BC
#...82139

ALTERED FLOOR PLAN 1:50

PLAN N° 2114

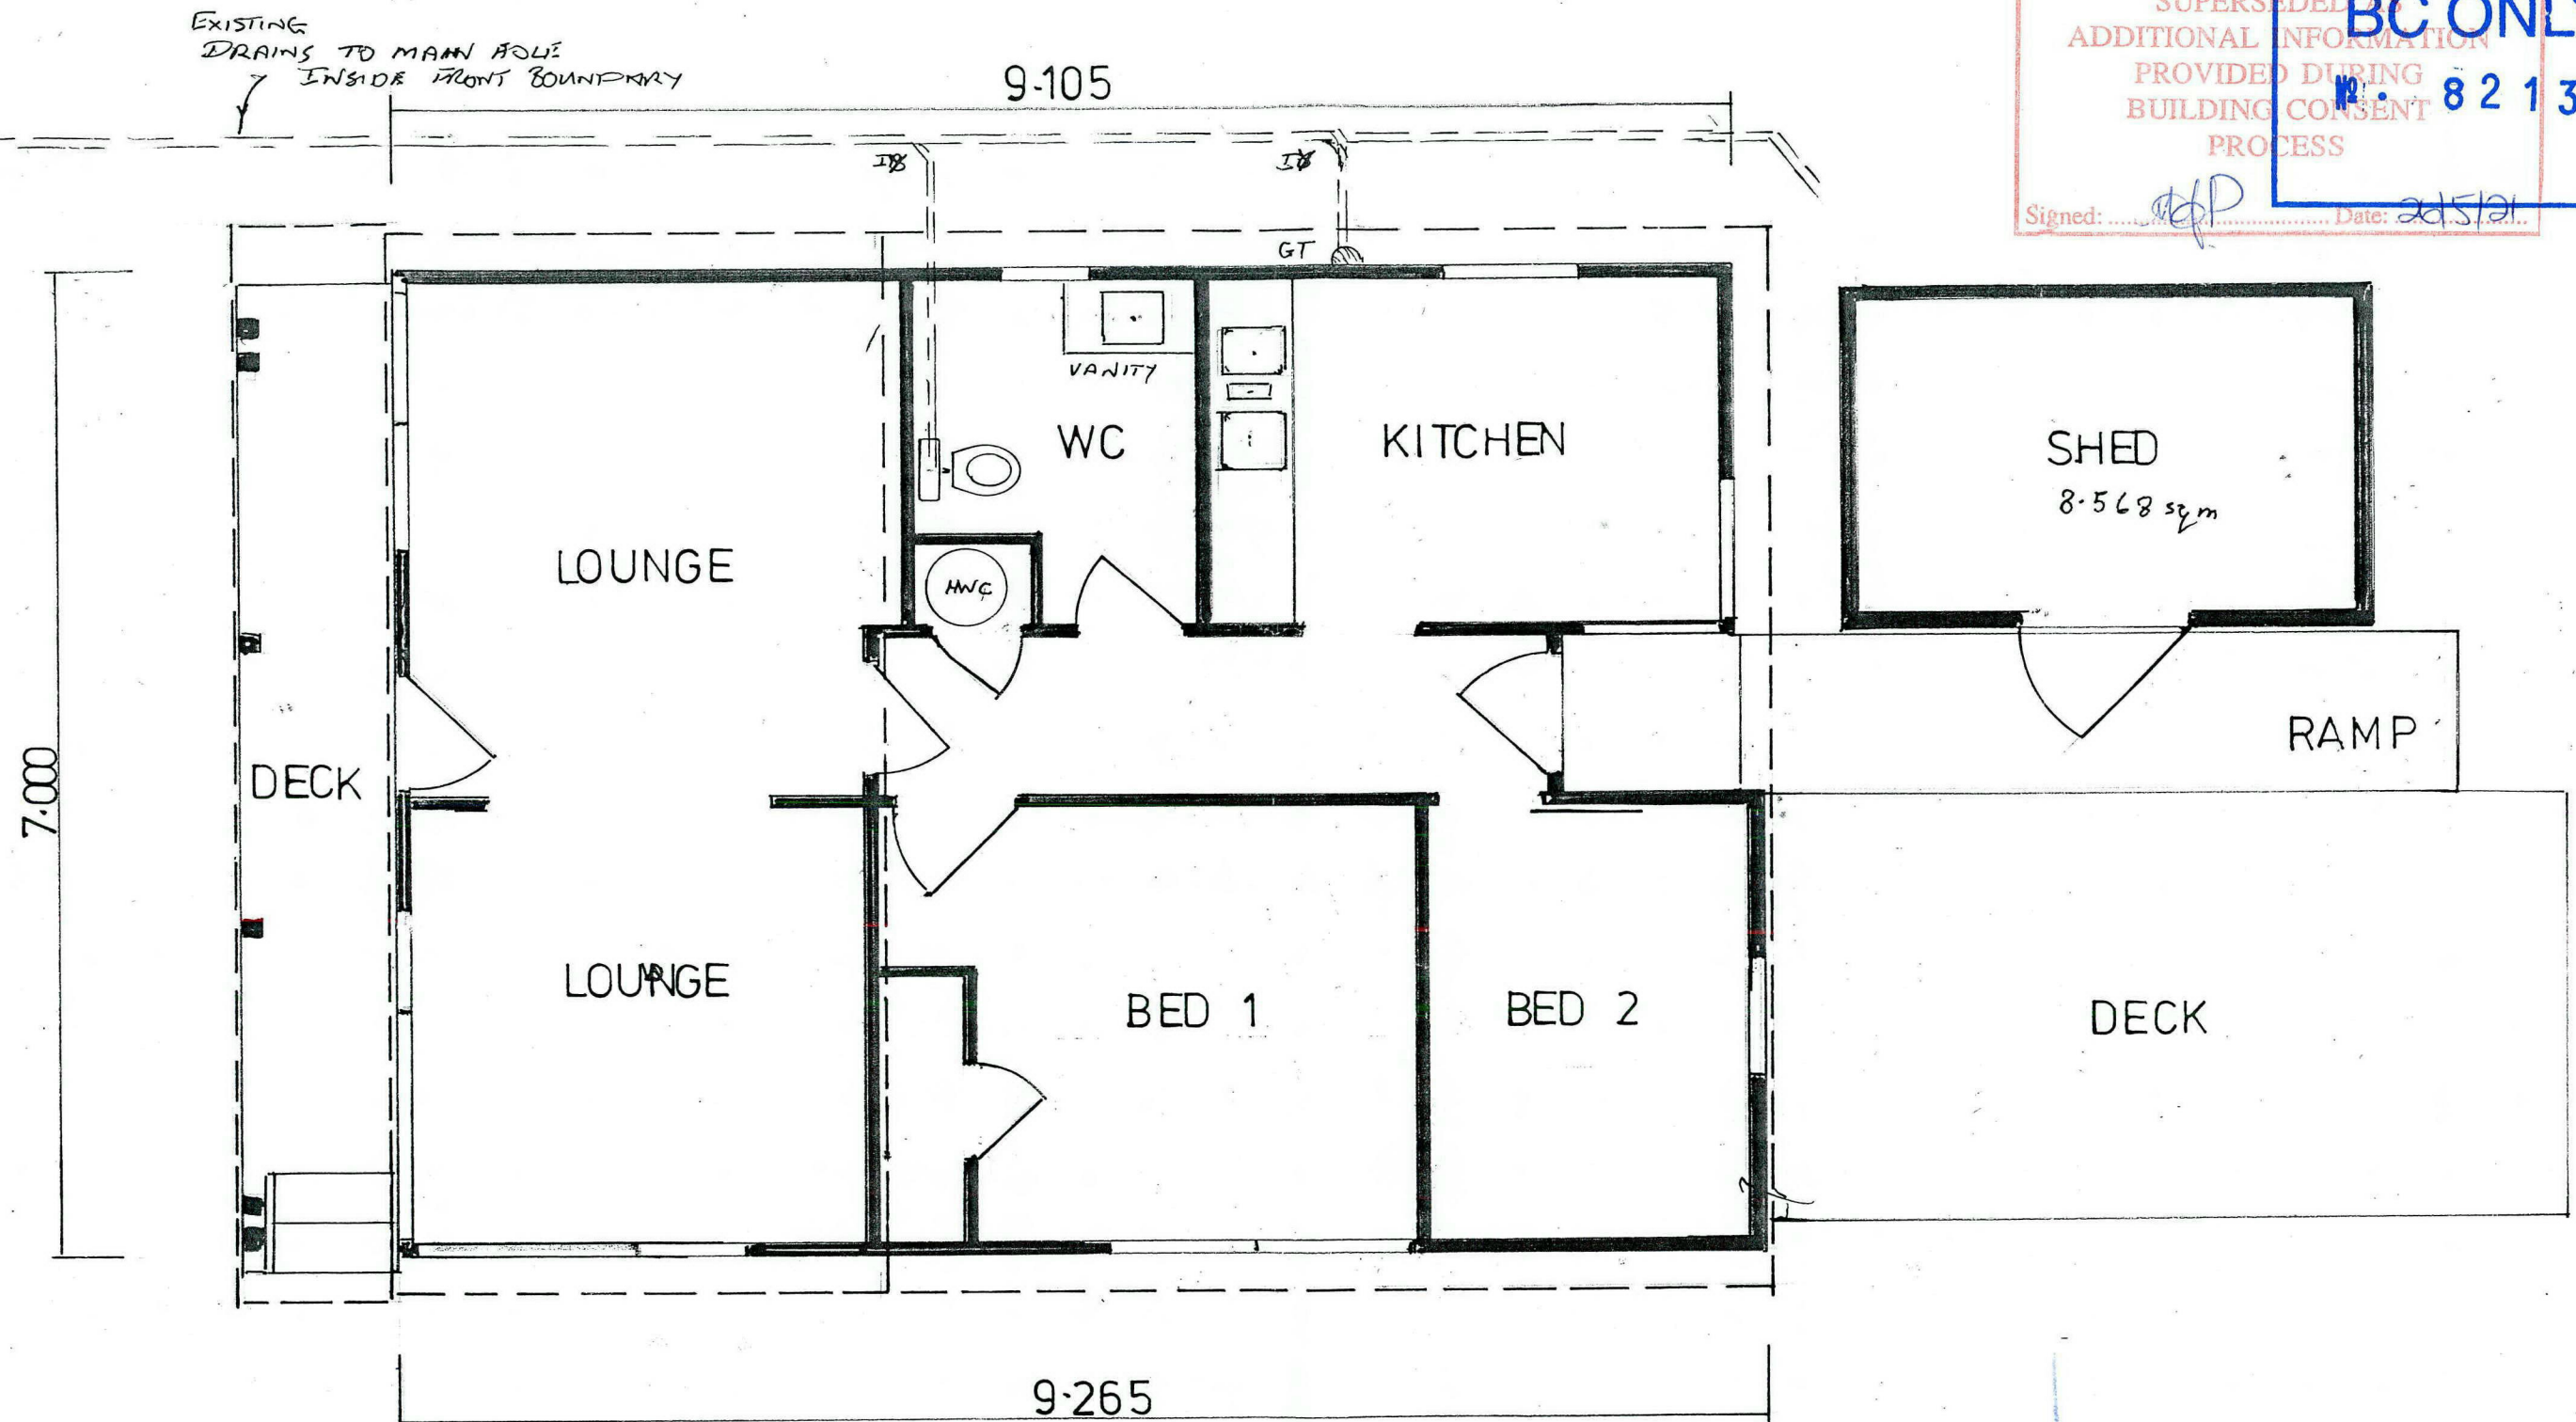
BATHROOM WINDOW TO BE
REGLAZED WITH
TOUGHENED SAFETY GLASS

LAY A NEW 19mm
PLY FLOOR OVER
EXISTING 12mm FLOOR.

LINE WALLS IN BATHROOM WITH
AQUAGIS OVER LAYED WITH
SERRATONE 2.

1.
VINYL FLOOR COVERING
TO BATHROOM
WALLS ARE NOW TO BE
SERRATONE.
